# SAN FRANCISCO PLANNING DEPARTMENT

## Discretionary Review Full Analysis

*Date:* August 31, 2011  
*Case No.:* 2010.0479DD  
*Project Address:* 1456 Chestnut Street  
*Permit Application:* 2010.06.16.4608  
*Zoning:* RH-3 (Residential House, Three-Family)  
40-X Height and Bulk District  
*Block/Lot:* 0480/003E  
*Project Sponsor:* John Schlesinger, A.I.A.  
351 Valley Street  
San Francisco, CA 94131  
*Staff Contact:* Aaron Starr – (415) 558-6362  
[Aaron.Starr@sfgov.org](mailto:Aaron.Starr@sfgov.org)  
*Recommendation:* **Take DR and Approve the Project with Modifications**

10'-3 3/8" 6'-0" 10'-0"

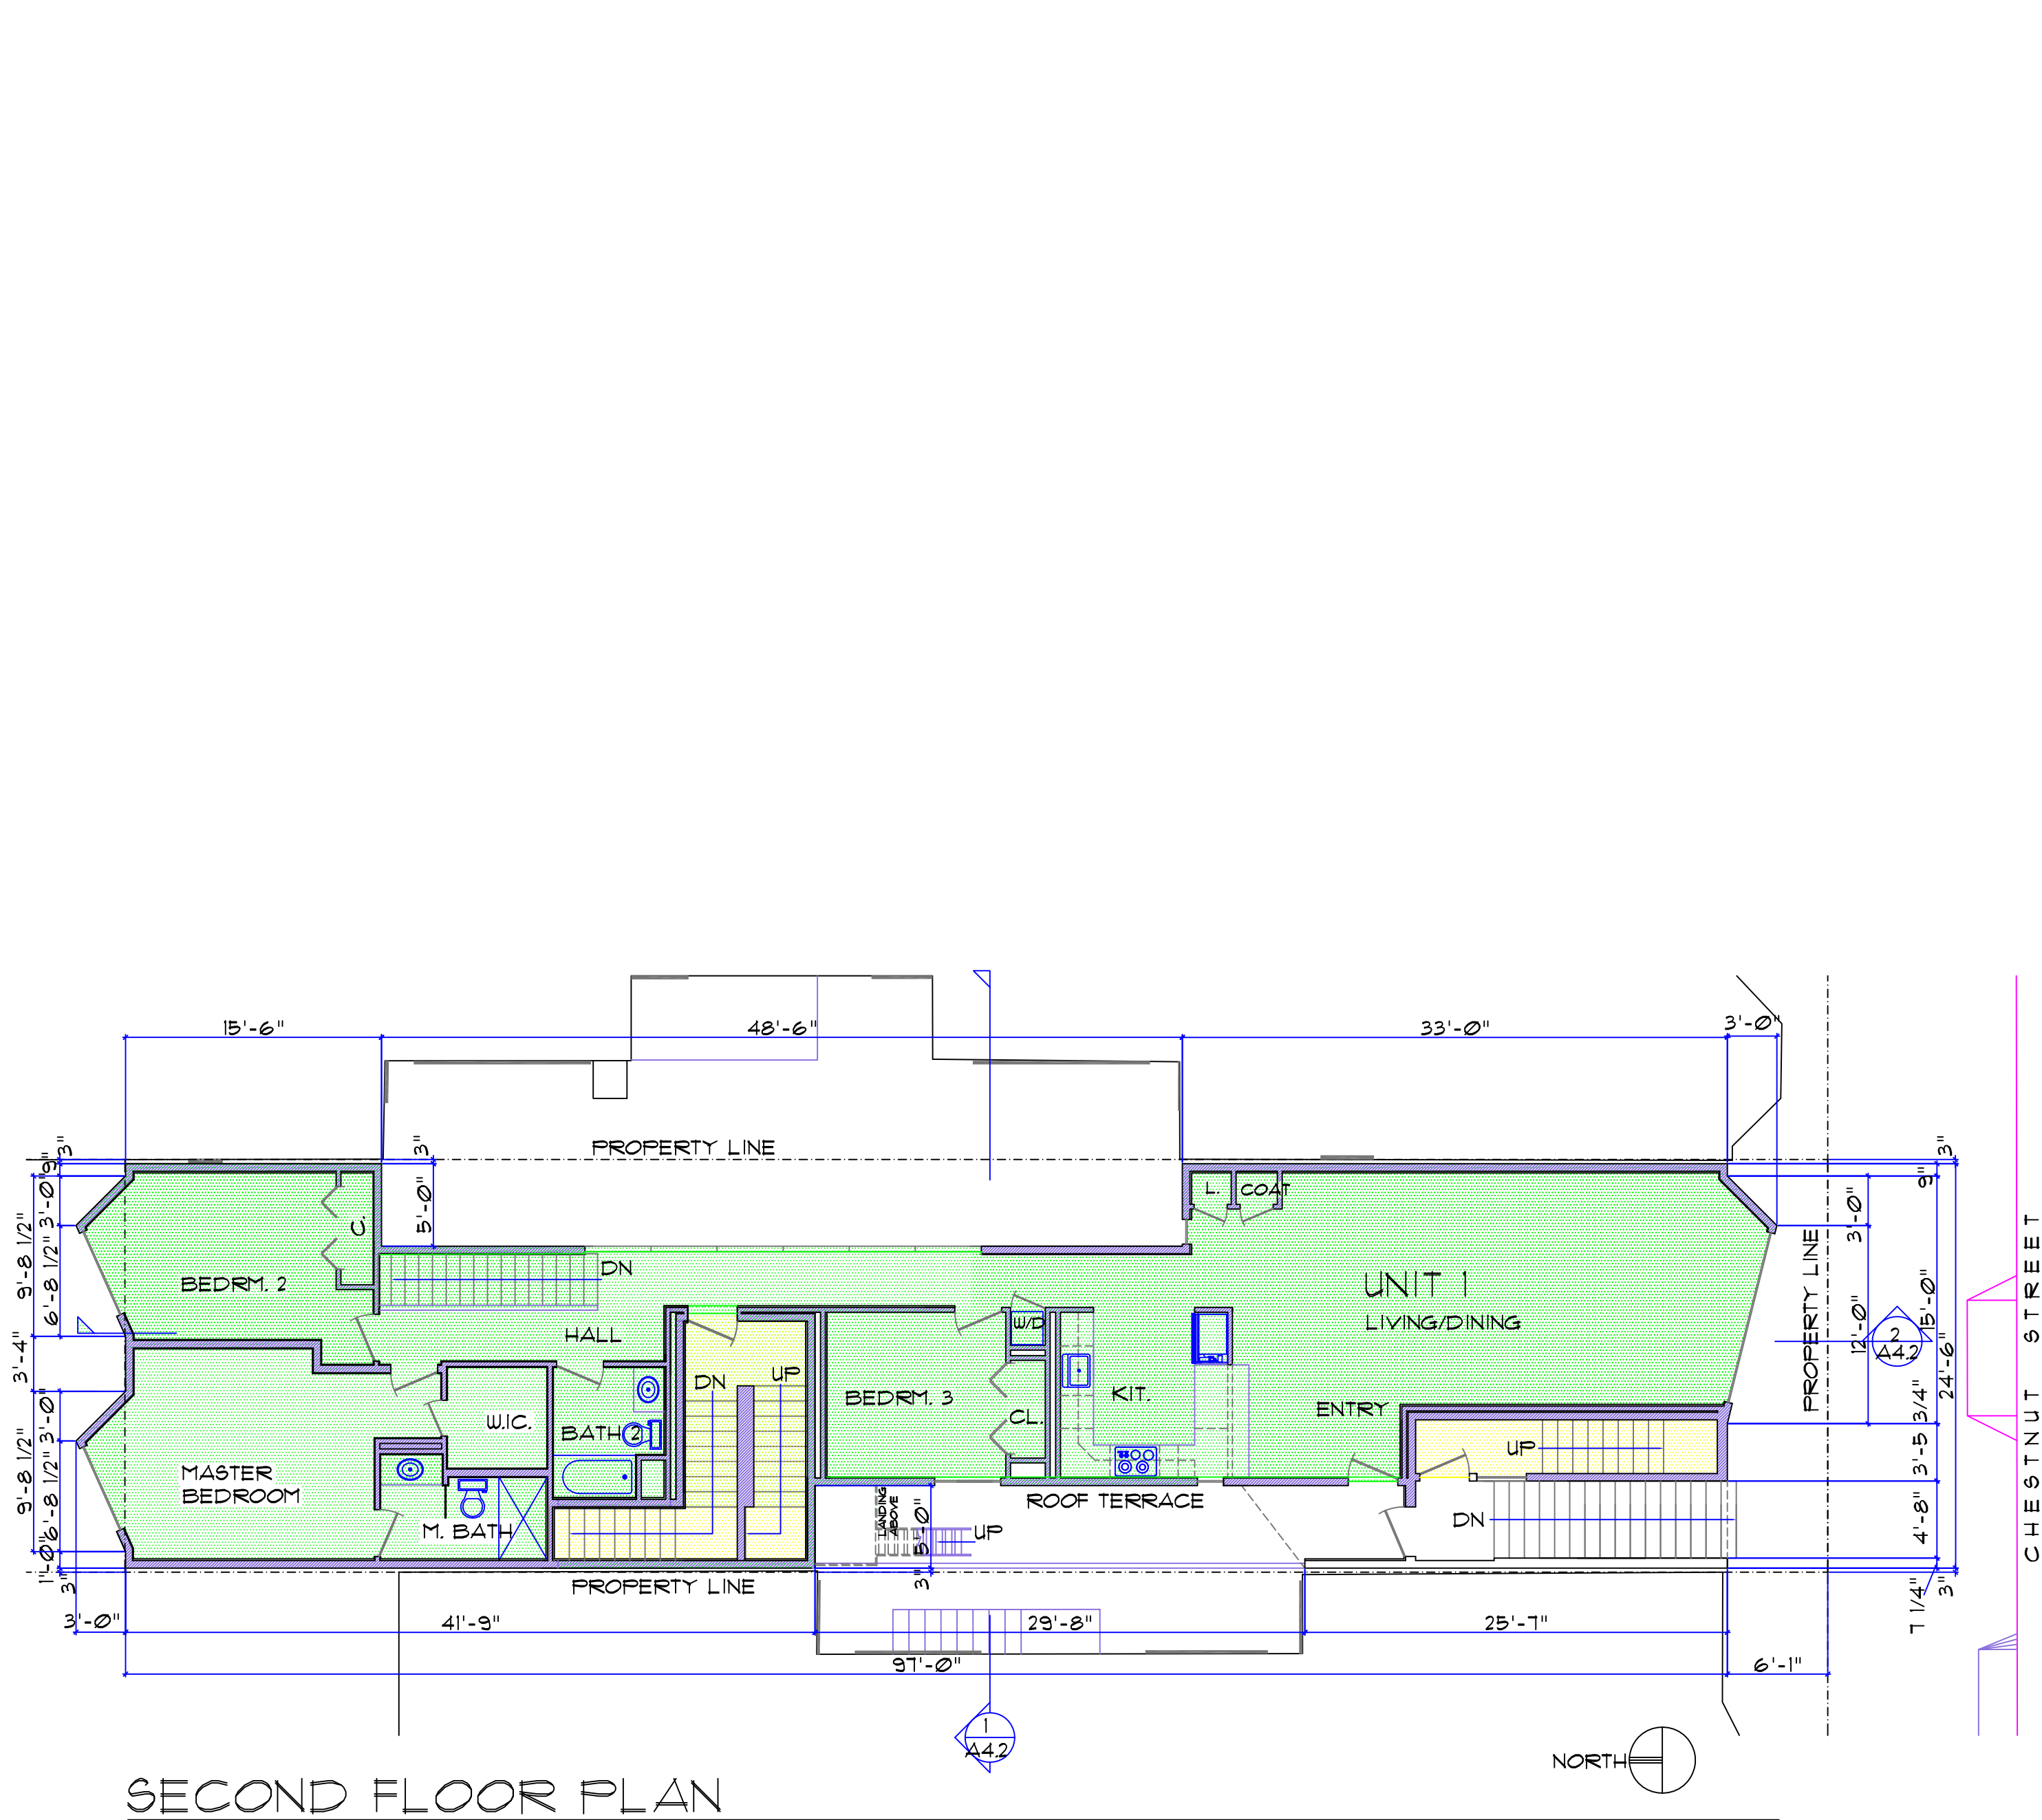
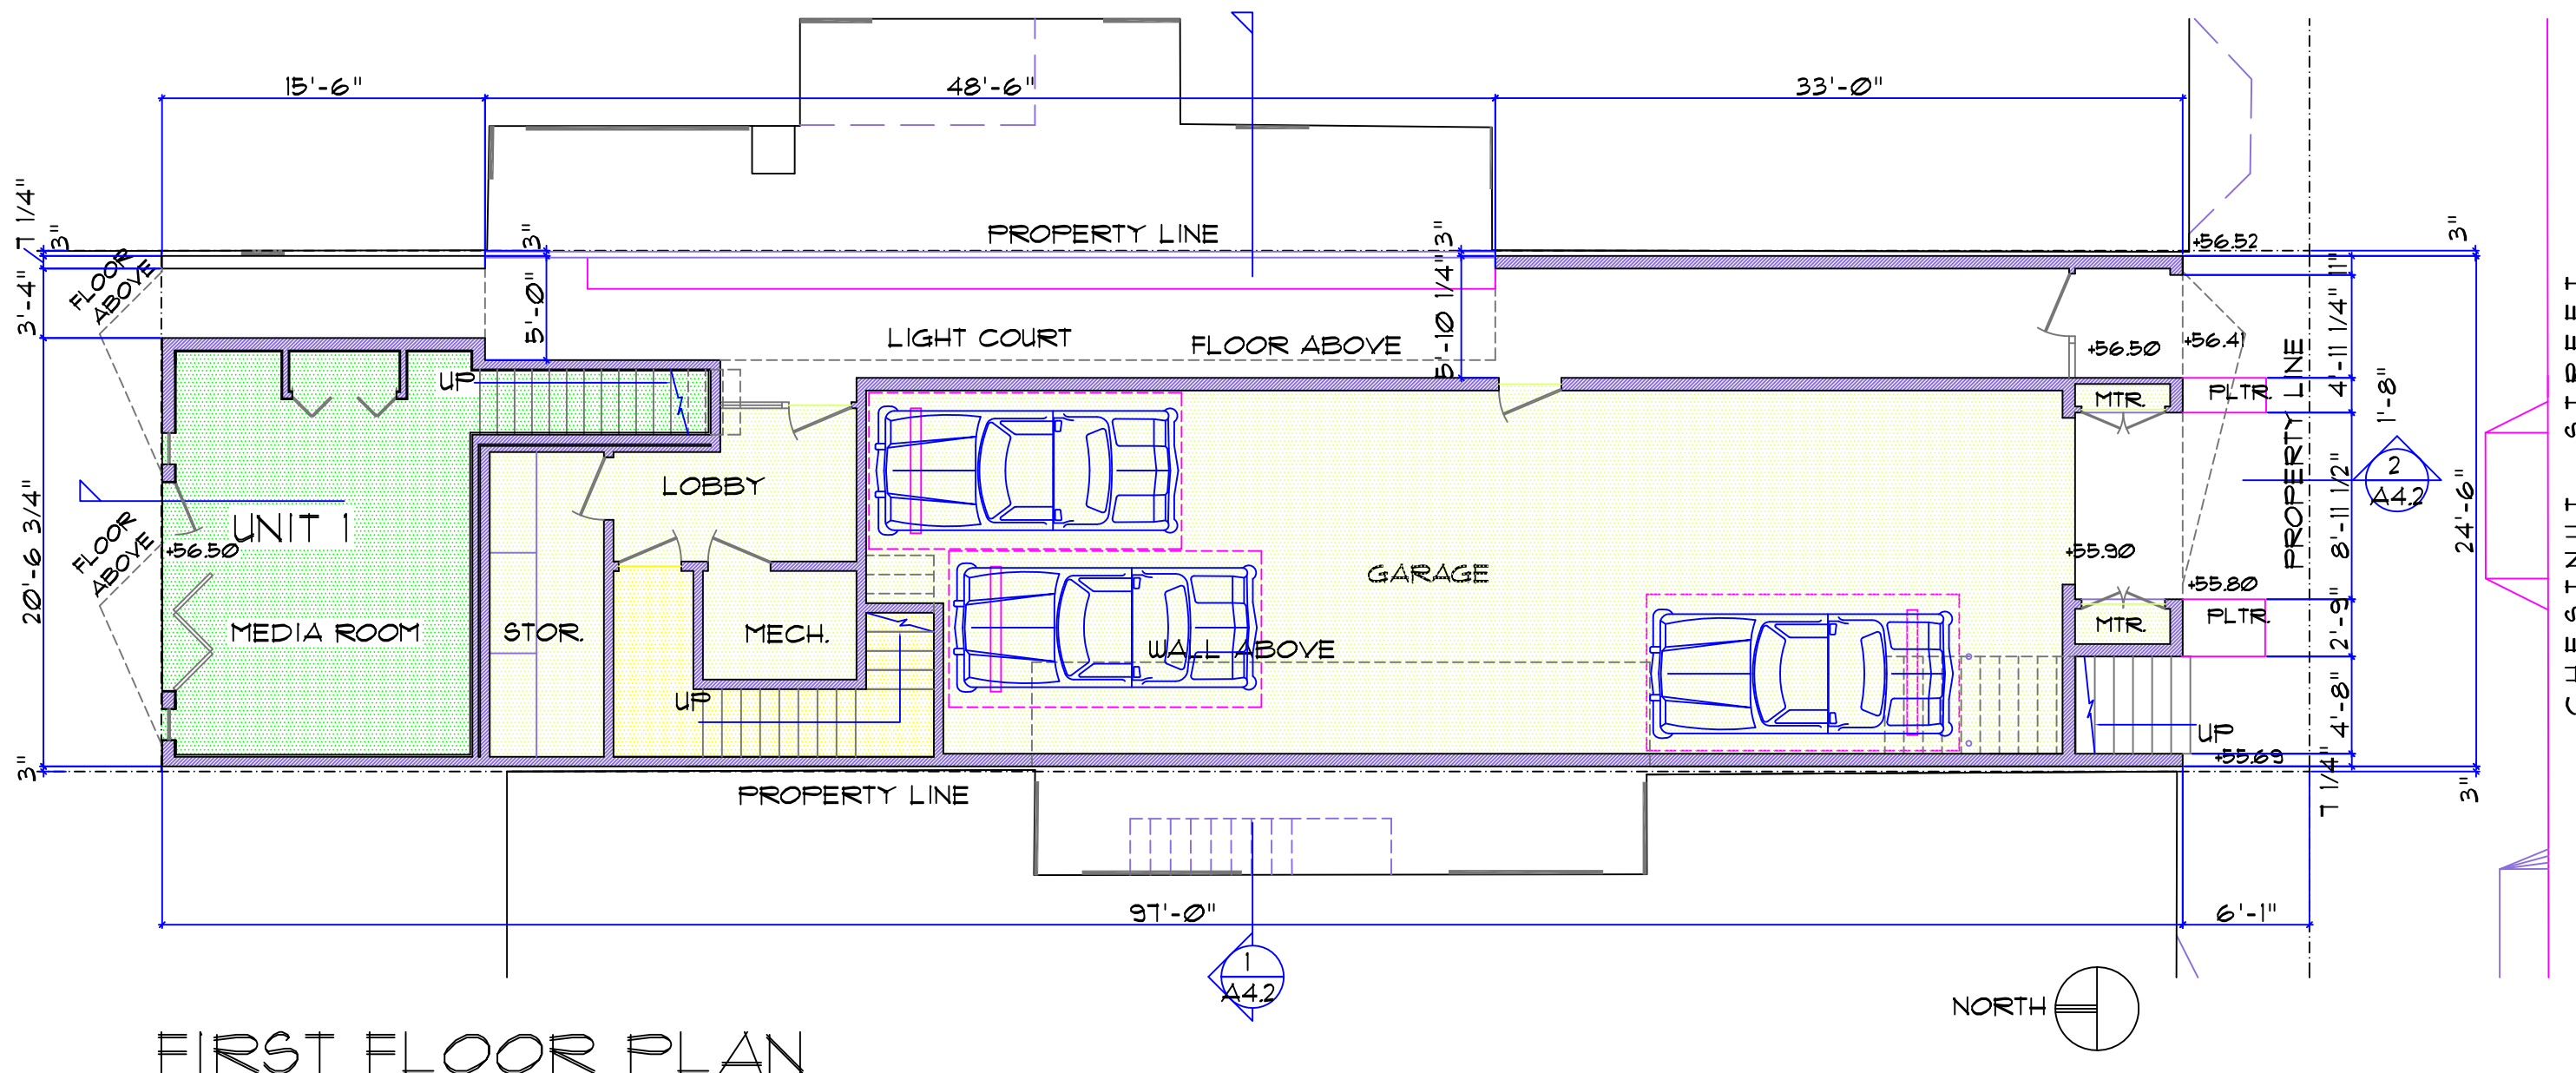
The RDT feels that the proposed depth of the project is appropriate, but has some concerns about the 4-story massing at the rear and its impacts on the smaller property to the west. As is typical, given these concerns the RDT asked that the project sponsor consider setting back the 4<sup>th</sup> floor in the rear to match the depth of the adjacent neighbor to the west. Also, the RDT suggested that there be a 10-foot side setback

against the shallower neighbor's property at the 2nd and 3rd floors. For the remaining 1-story portion at the west side property line, the Department asked that the deck railing be set back from the property line so that no fire wall would be required. These requirements were intended to minimize loss of light to the adjacent property to the west and to avoid a large solid blank wall at the property line.

**The Department is seeking the Commission's feedback on this specific issue.** RDT staff acknowledge the value of the larger-than-required lightwells, both to the proposed 3 units and the multiple units in the buildings on either side that have windows facing the lightwells. However, the large lightwells squeeze the floorplans of the proposed units into a barbell shape, which somewhat forces living areas and bedrooms to the front and rear of the site. The RDT's request for a 10-foot side setback on the west side therefore has a larger-than-usual impact on the floorplan, when combined with the proposed west side lightwell.

The Department also suggests that the stair penthouse be moved to the east side of the roof so that it would not be on the most visible side of the building as seen from the street. The proposal is a new building and is not limited by existing conditions.

**SK3**

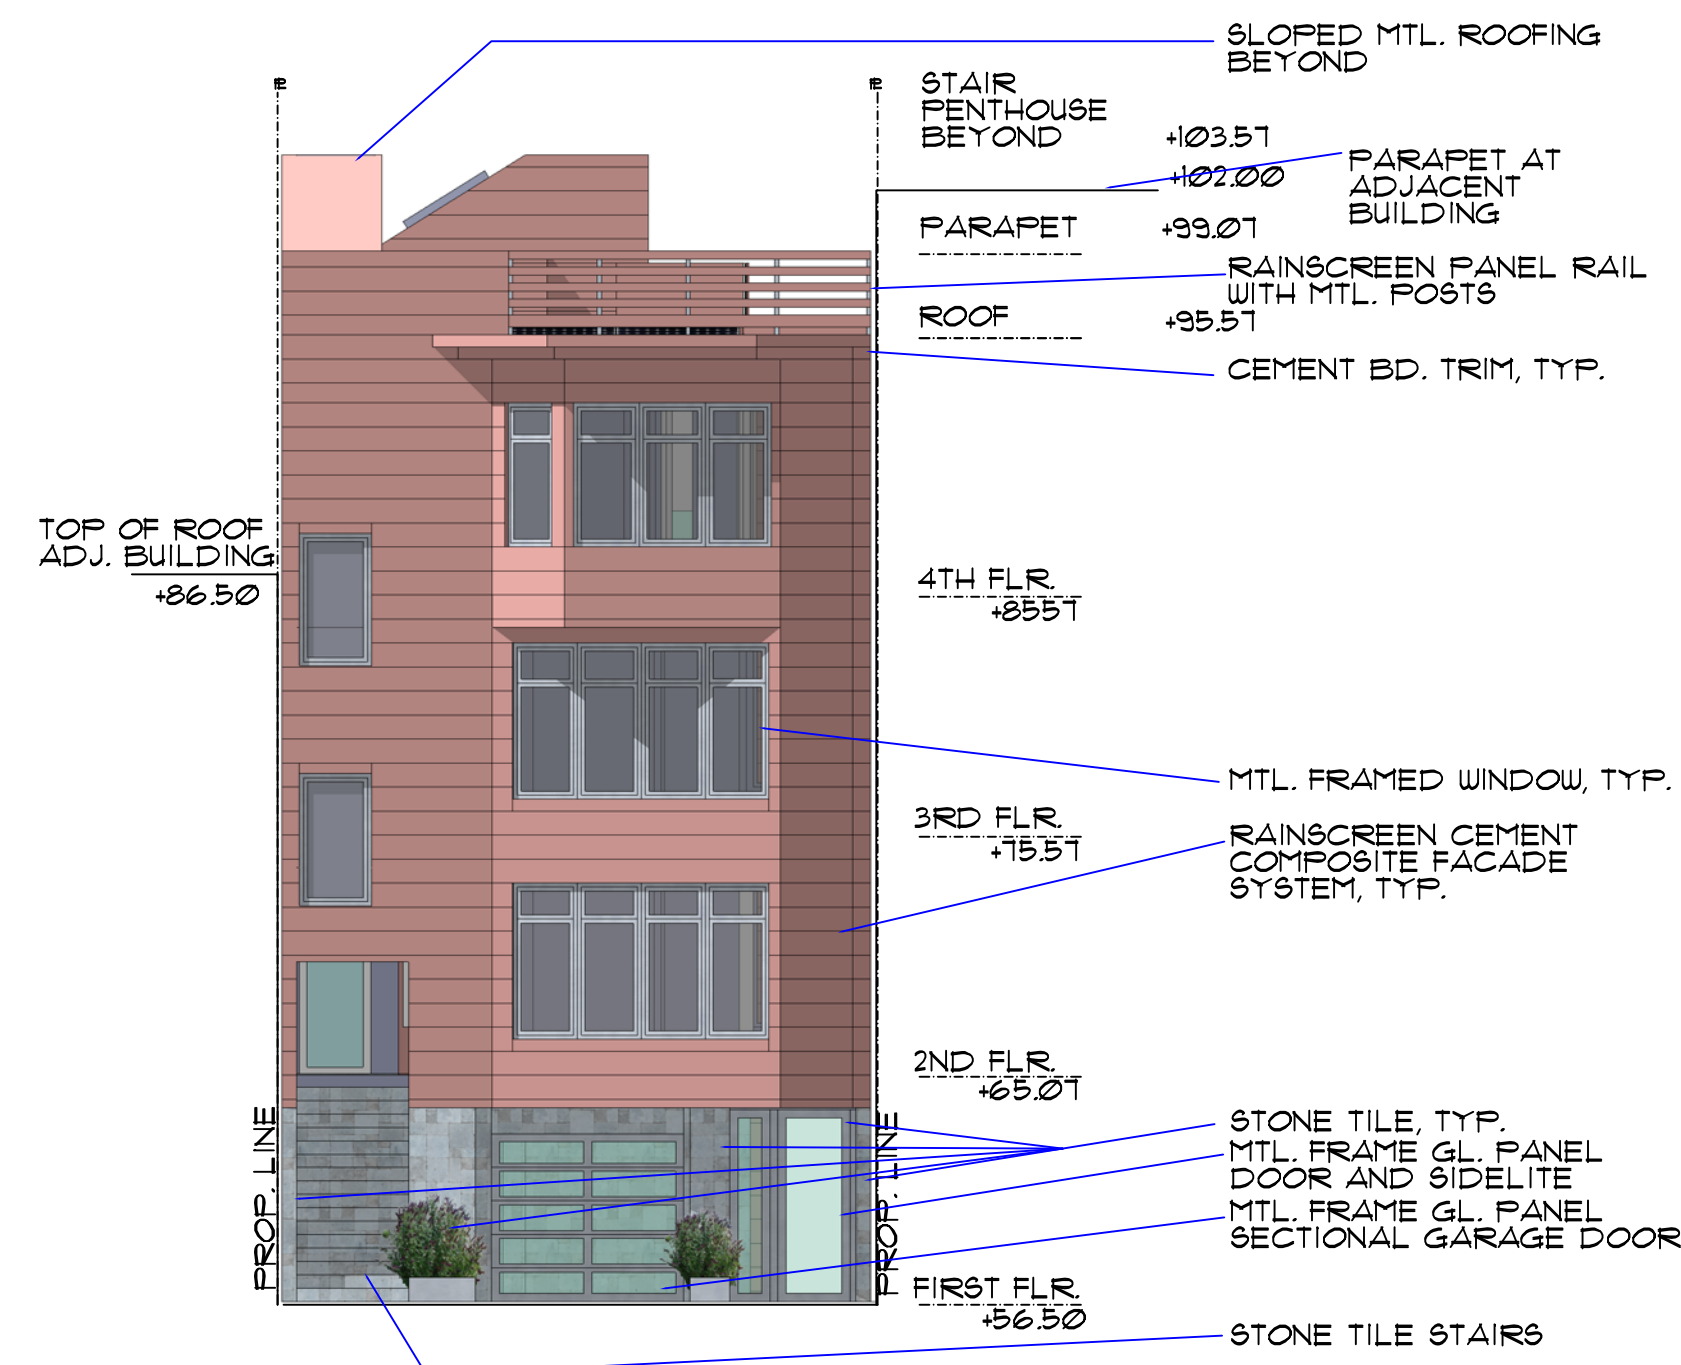
The building design reinterprets design features found on neighboring buildings. The ground floor entries are similar to 1436-38 Chestnut Street. The window bays take their cues from the adjacent neighbors; however their geometry allows for retaining the privacy to the existing bays at the adjacent buildings (**See sheets SK0-SK1**). The bay windows at the rear of the property are angled away from the larger apartment building to the East, to maintain privacy to existing property line windows that serve dining areas to existing apartments. The rear yard provides open space for the unit at the first and second floors. The rear 10 ft. of the building is set back at the fourth floor to accommodate a roof terrace for the unit at the fourth floor, while diminishing the bulk of the building against its neighbor to the West. A roof top terrace is set back from the rear of the fourth floor to maintain privacy between units, while providing open space to the unit at the third floor (**See sheet SK2**). The windows in the matching light wells are offset from windows facing the adjacent buildings, to maintain privacy between buildings. The glazing at the light well facing 1450 Chestnut Street to the East will be translucent as well (**See sheet SK3**).
